**West Side Operations Center Supply Building Drainage Improvements**  
**Solicitation Number: CO-00729**  
**Job No.: 22-0152**

**ADDENDUM 2**  
**April 10, 2024**

WESTSIDE OPERATIONS CENTER  
 SUPPLY BUILDING DRAINAGE IMPROVEMENTS  
**PROPOSED ENLARGED PLAN**

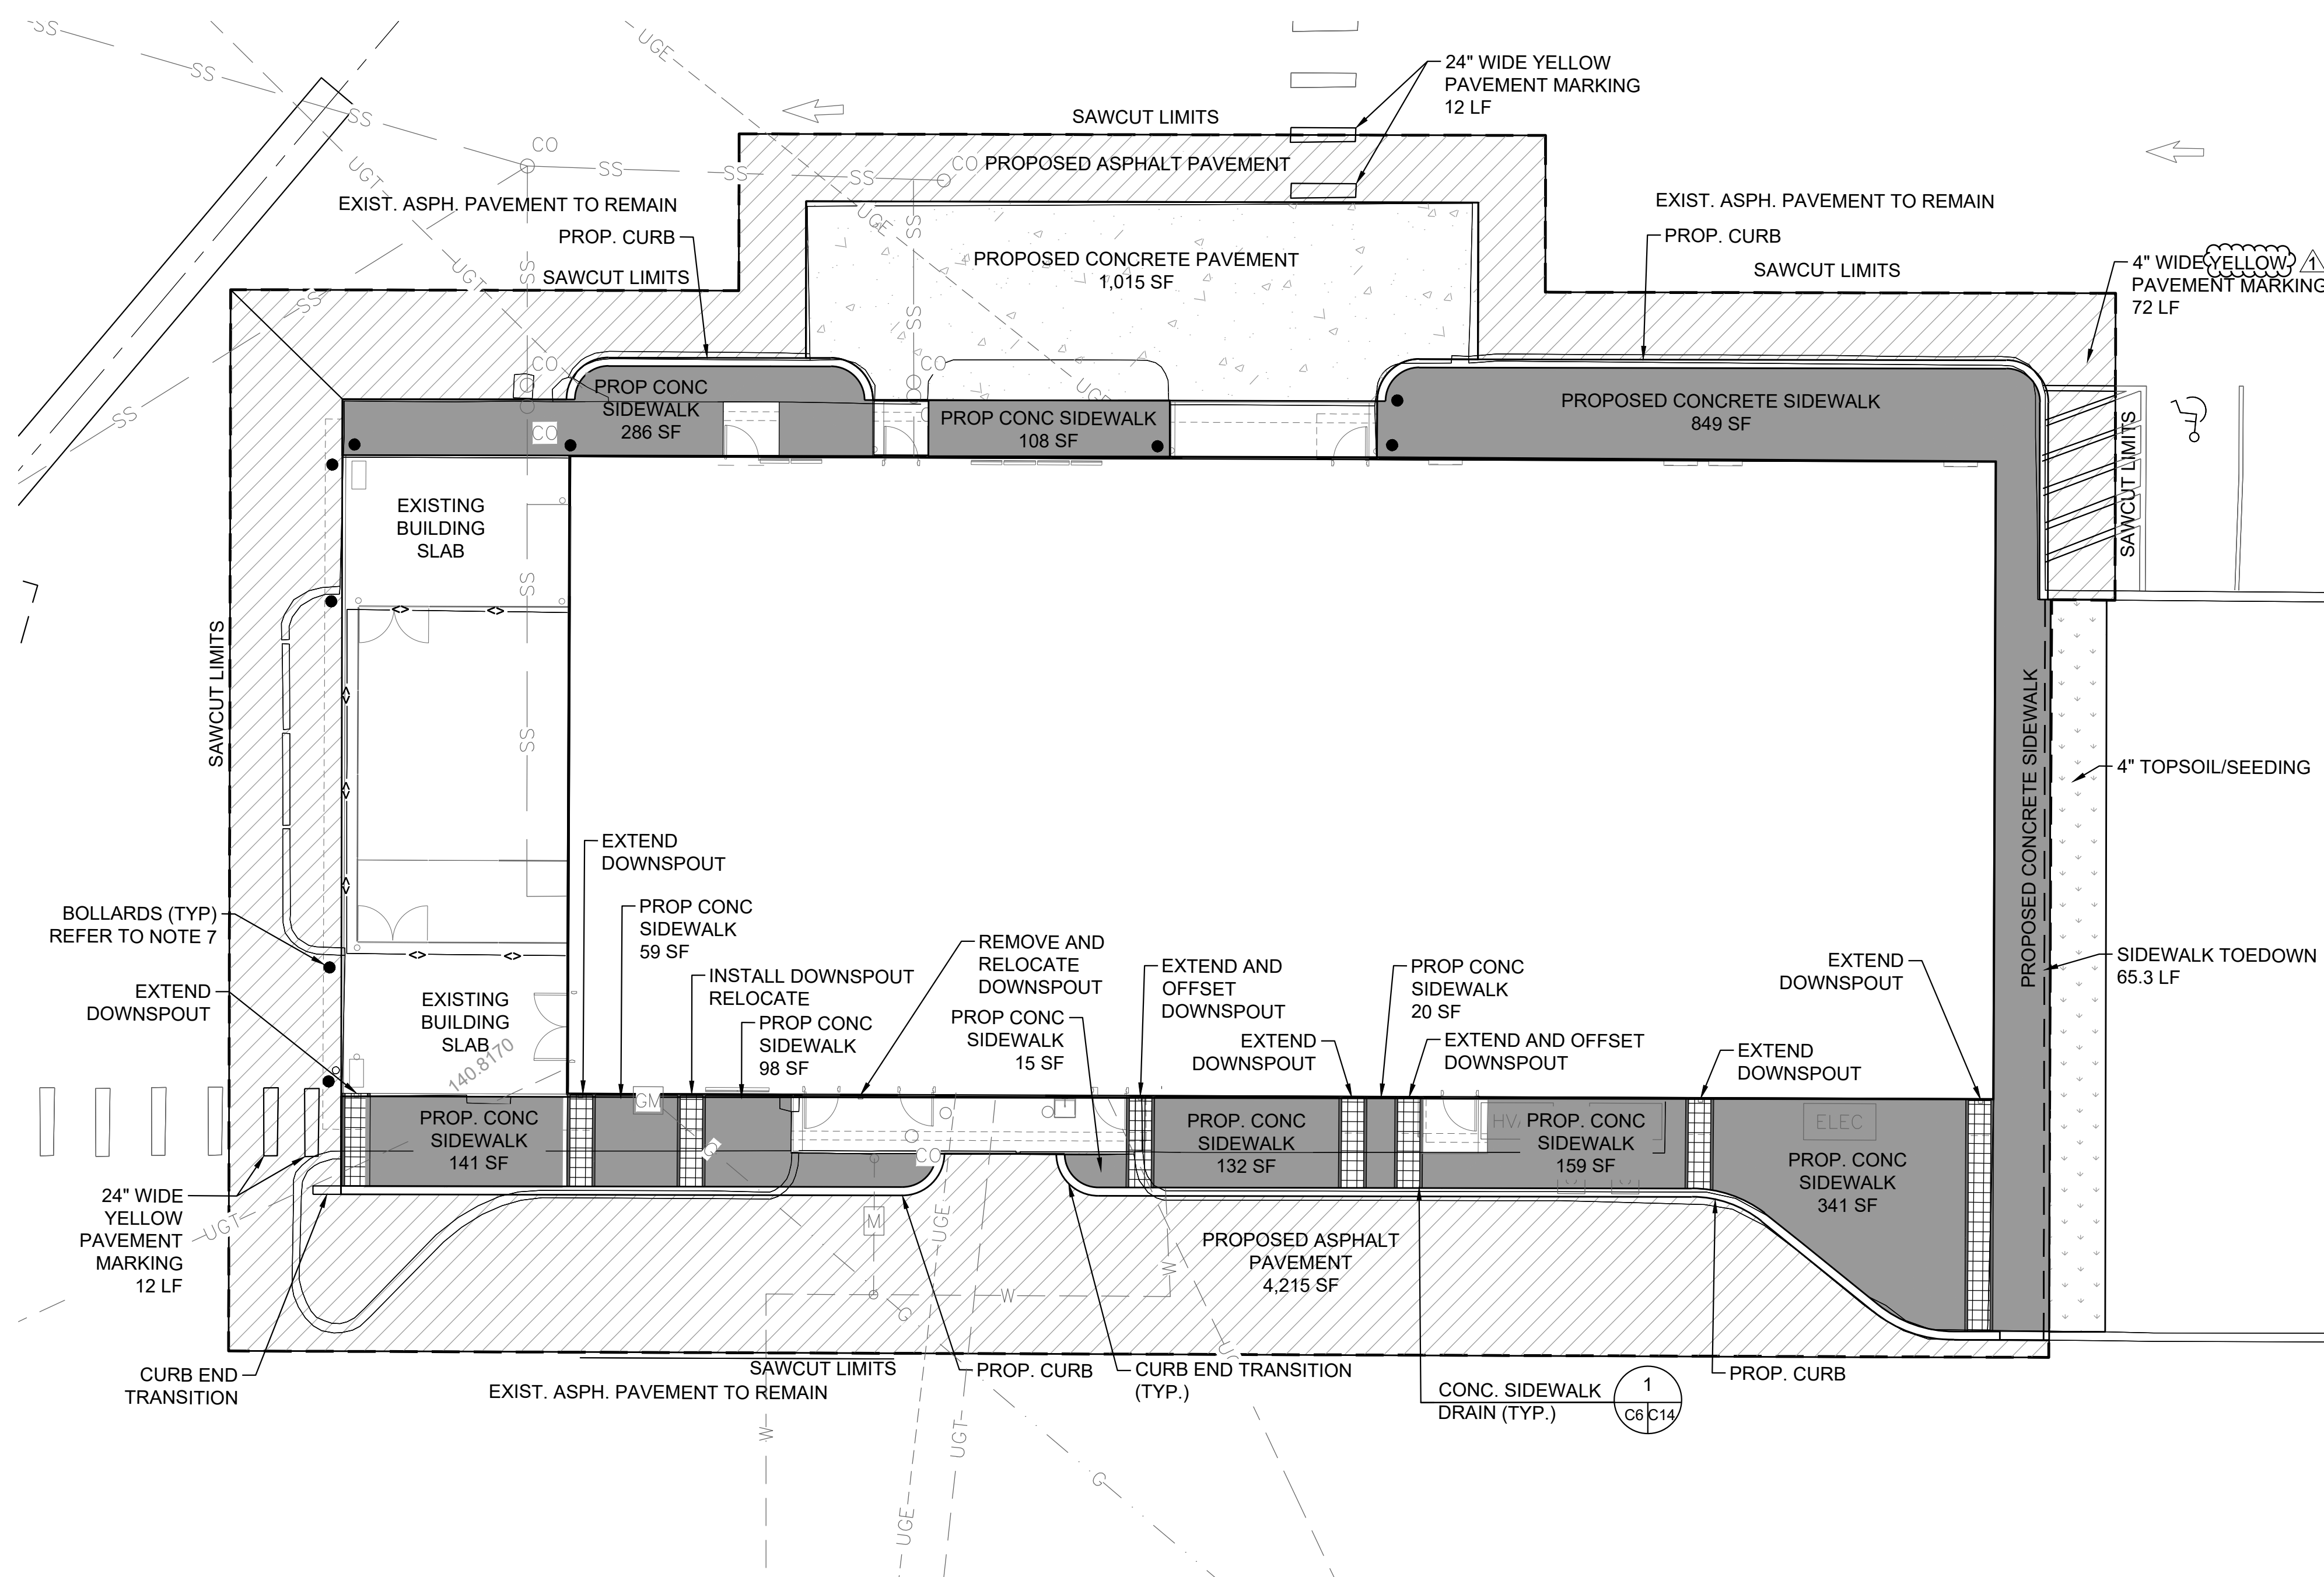
- 3. Question:** Please verify proposed pavement marking 4" white quantity. Also, existing marking is yellow.

*Response: There are no 4-inch white pavement marking quantities on the plans. See the "Changes to the Plans" section below.*

- 5. Question:** Are there any proposed bollards on this project?

*Response: Yes, refer to Sheet C6 and Sheet C14 in the plans.*

- 7. Question:** Are there any downspout relocations on the project?

*Response: Yes, refer to Sheet C6 and Sheet C16 in the plans.*

- Sheet C6 – Proposed Enlarged Plan
- Sheet C19 – Storm Water Management Plan

**C19**  
SHT 24 OF 33

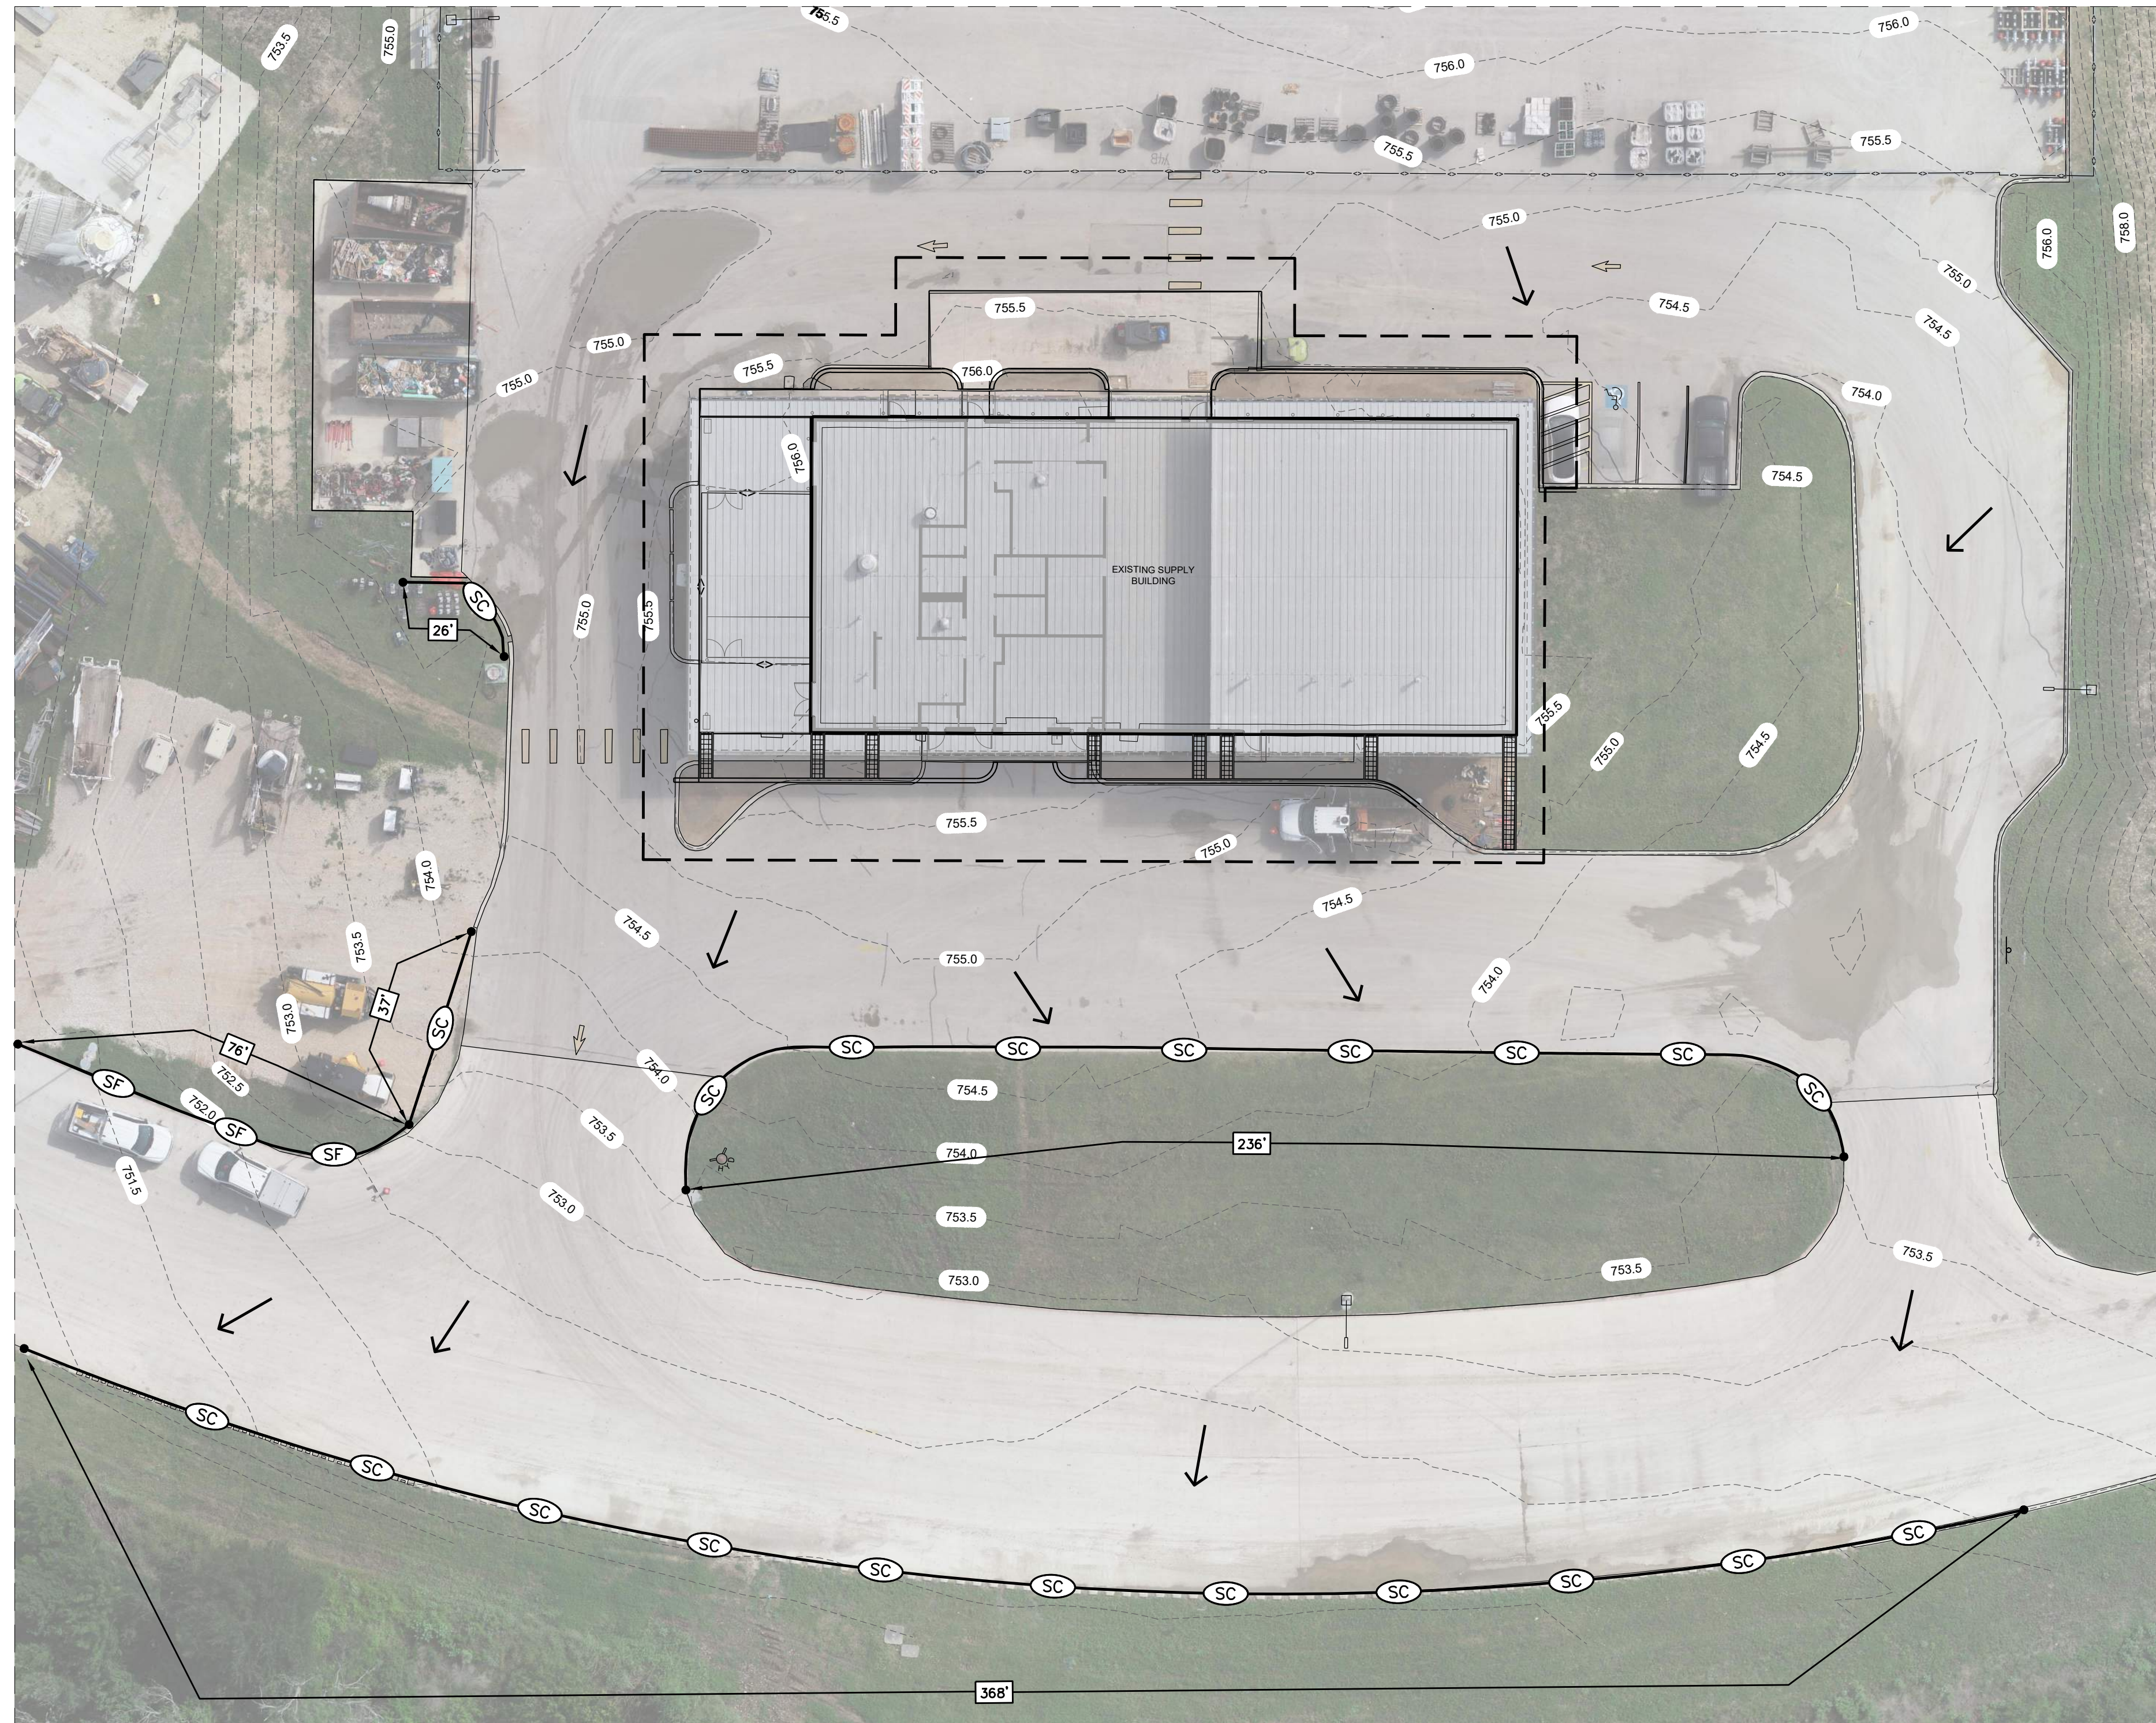
- 4. Question:** Spec page 208/216 calls for 8" biodeg erodin cont logs, detail on plan page C20 calls for 12". Please clarify.

- 6. Question:** Scale on plan page C19 is incorrect. Should be 1" to 20'.

*Response: Use 12" biodegradable erosion control logs. See the "Changes to the Specifications" section below.*

*Response: Yes, scale on Sheet C19 should be 1"= 20'. See "Changes to the Plans" section below.*
